Version 2

Safety Recall: 2018–22 Odyssey SRS Software Update

Supersedes Version 1 to revise the information at:

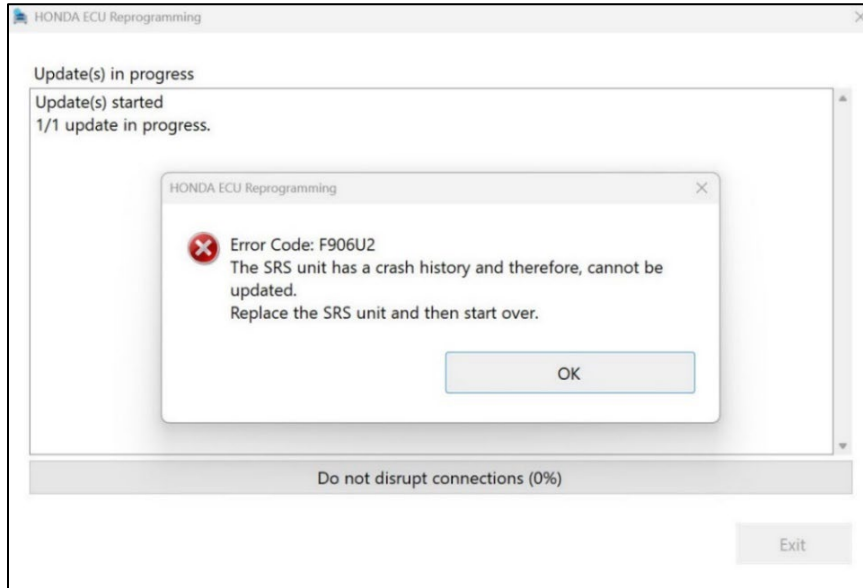
- If the SRS unit cannot be updated and displays the following error message, proceed to **REPAIR PROCEDURE B**.
- A clear photo documenting the HDS screen failure **will be required** for warranty processing.
